COVER SHEET
C0.0
1 of 53 Sheets

EAST TOWN CROSSING PHASE 1

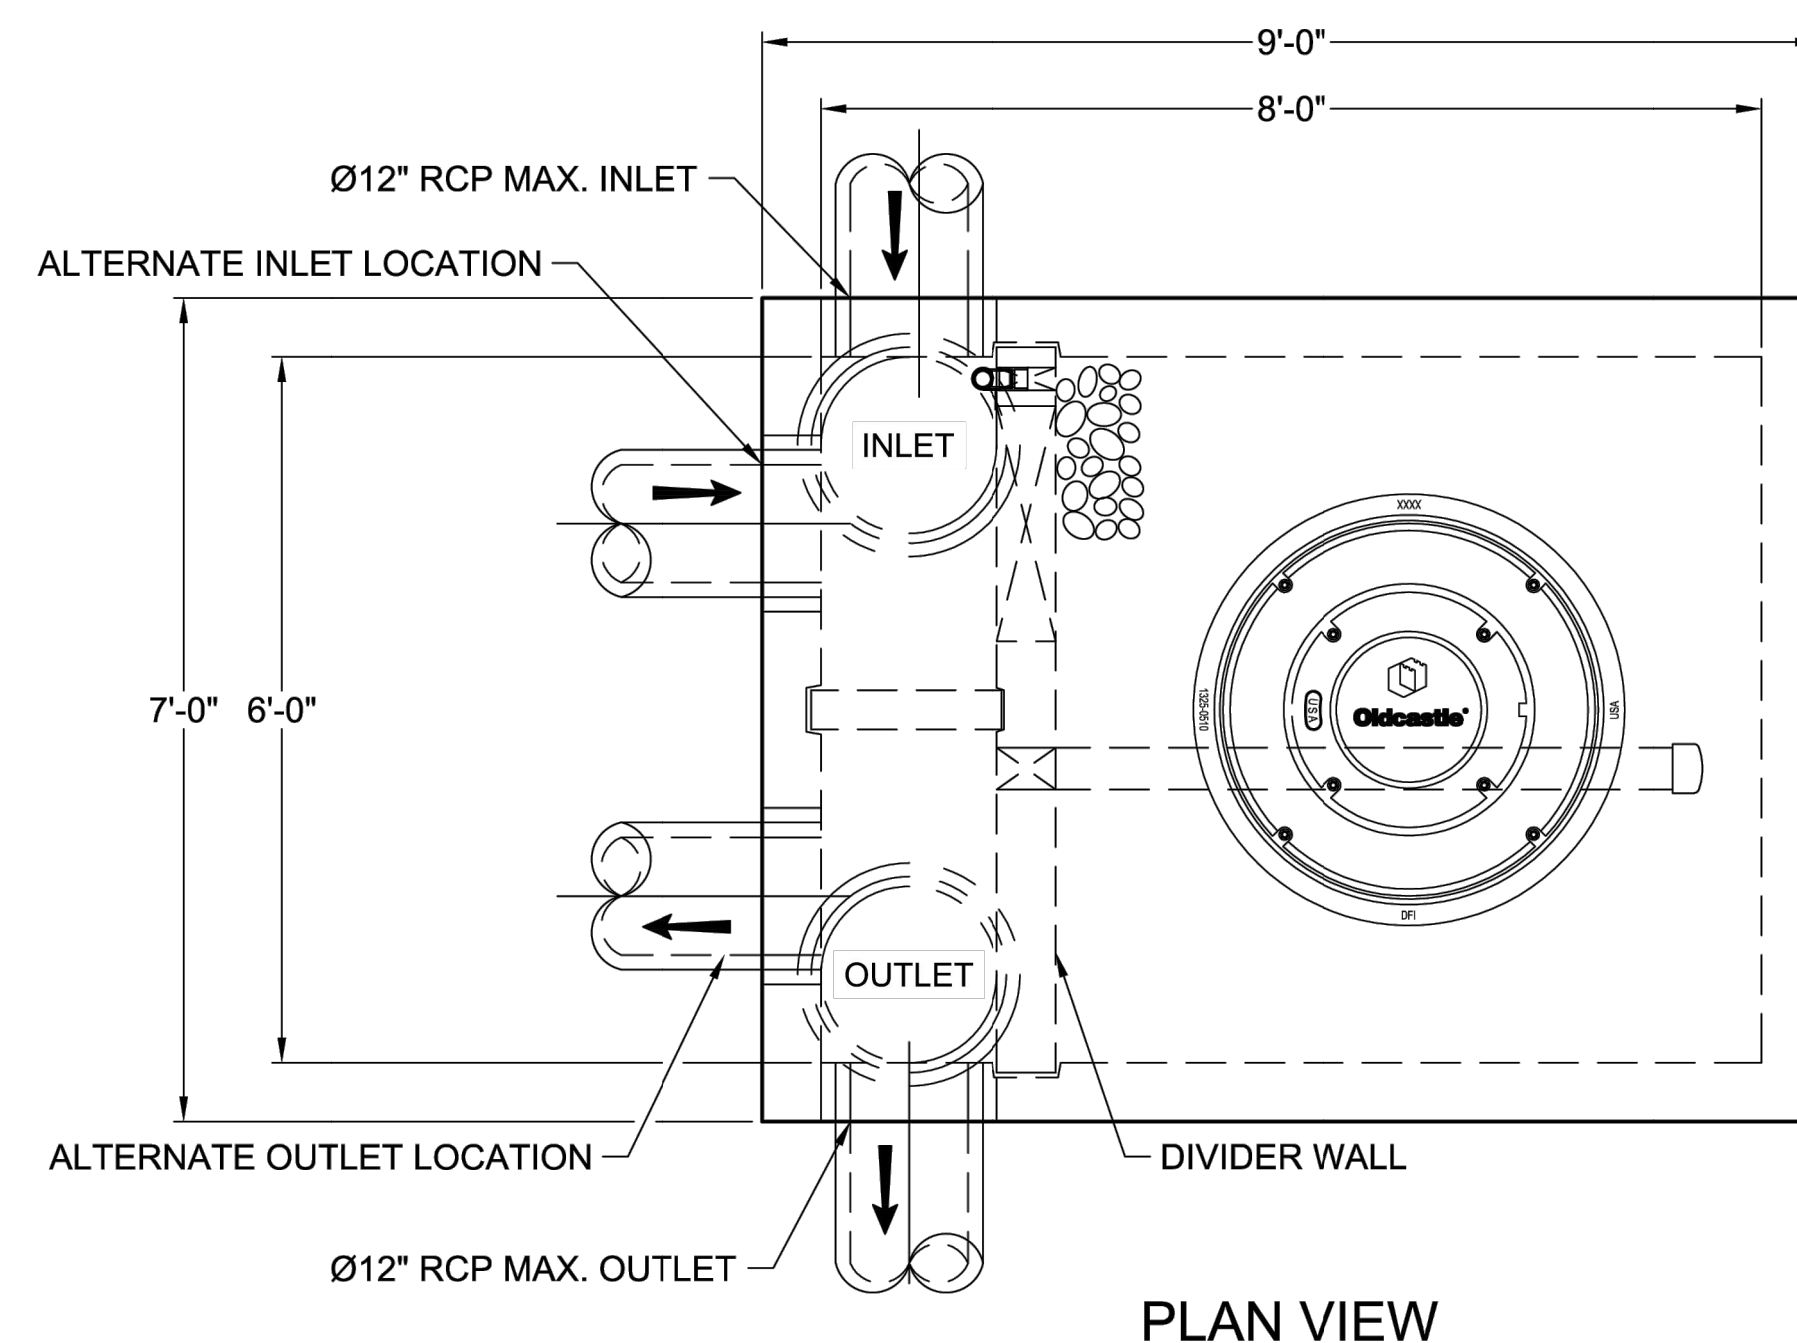
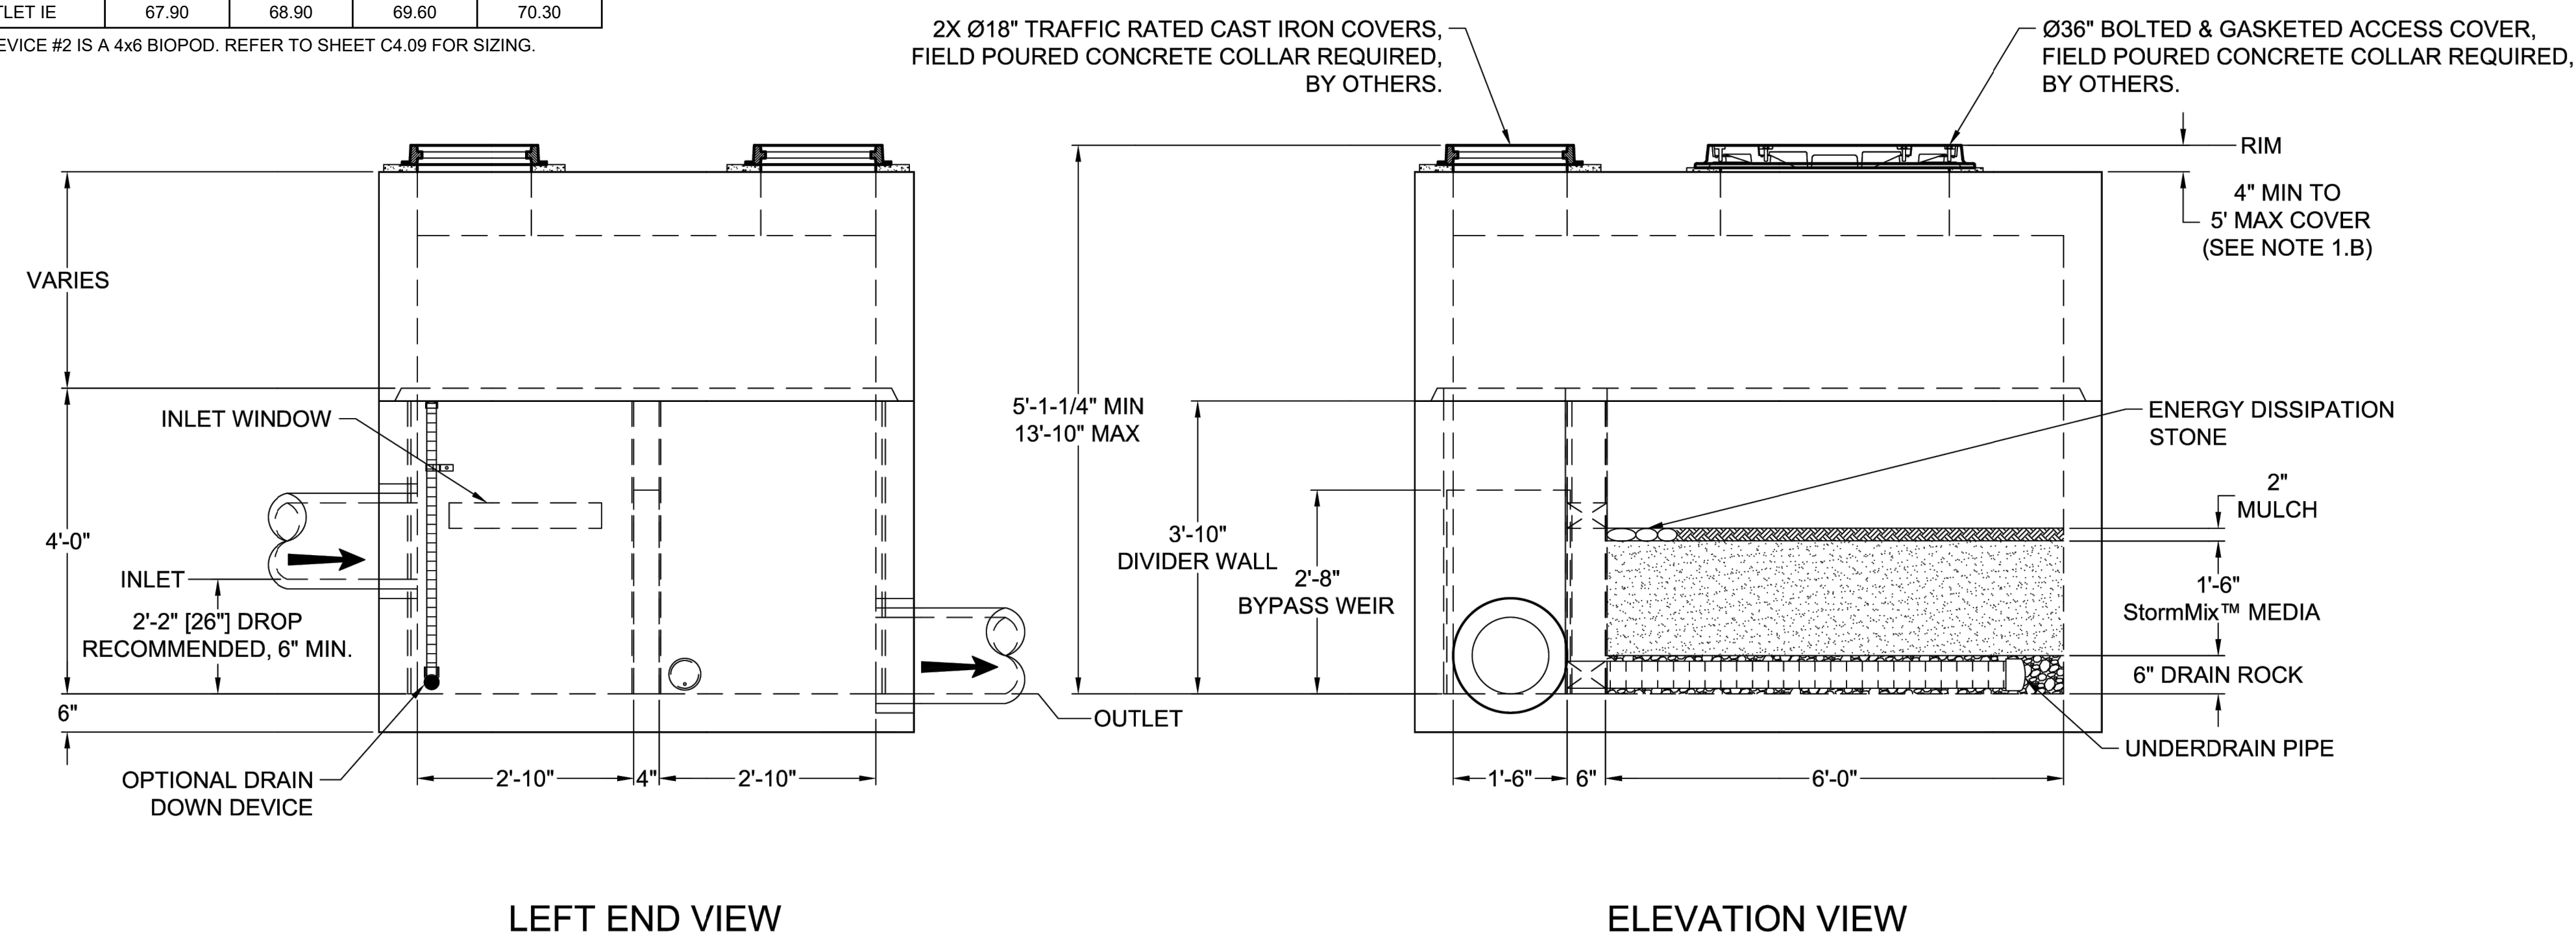
VERIFY-SDCB91 [Plans Sht C4.07; Pg 21 of 53]

Per prior comment, shouldn't this be EI. 67.40 which is the bottom of storage and the invert of the outlet pipe? EI. 67.65 would place the orifice on the toe of the control riser. [Plans Sht C4.07; Pg 21 of 53]

VERIFY-Is it necessary to have such a large control riser and inlet/outlet pipes at SDCB10? [Plans Sht C4.07; Pg 21 of 53]

VERIFY-per calcs the orifice is located at 4.22R (EI. 72.65). [Plans Sht C4.07; Pg 21 of 53]

VERIFY-Per prior comment, per calcs there is 5.87ft of storage which places the riser crest at EI. 74.21 (Bottom of Storage EI. 68.40 + storage depth of 5.87). [Plans Sht C4.07; Pg 21 of 53]

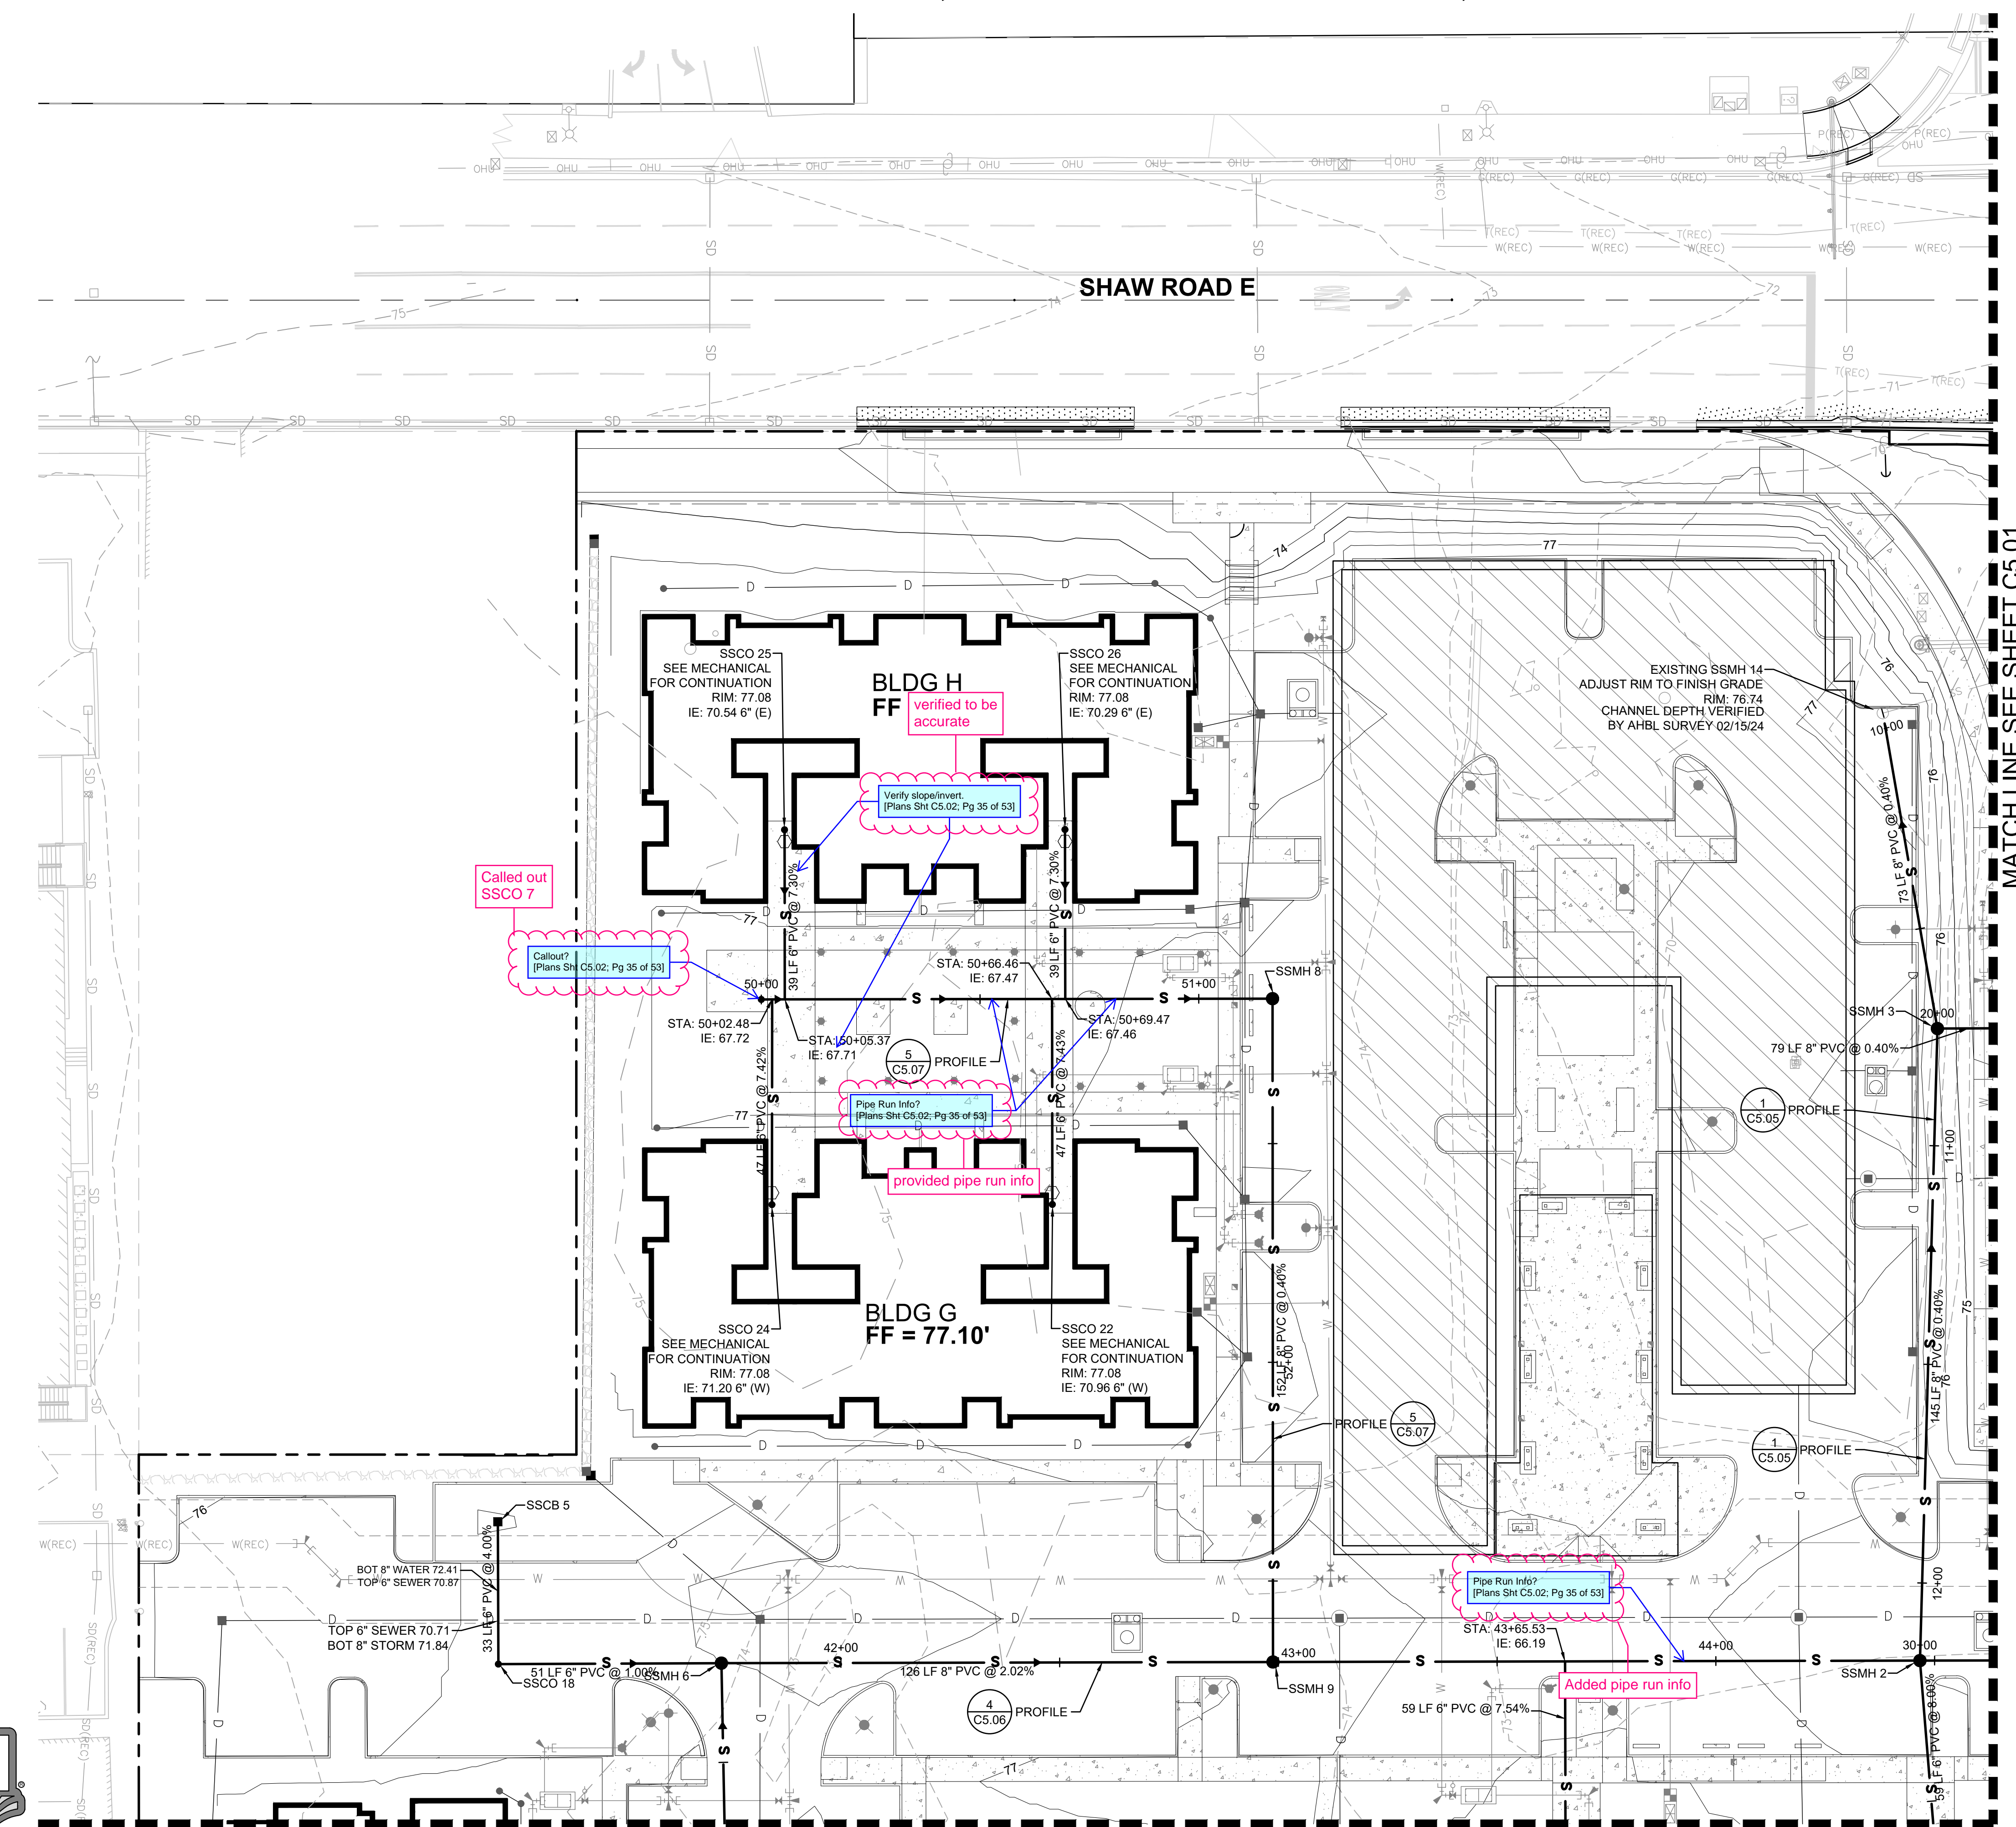
Callout? [Plans Sht C5.02; Pg 35 of 53]

Verify slope/invert [Plans Sht C5.02; Pg 35 of 53]

Pipe Run Info? [Plans Sht C5.02; Pg 35 of 53]

Pipe Run Info? [Plans Sht C5.02; Pg 35 of 53]
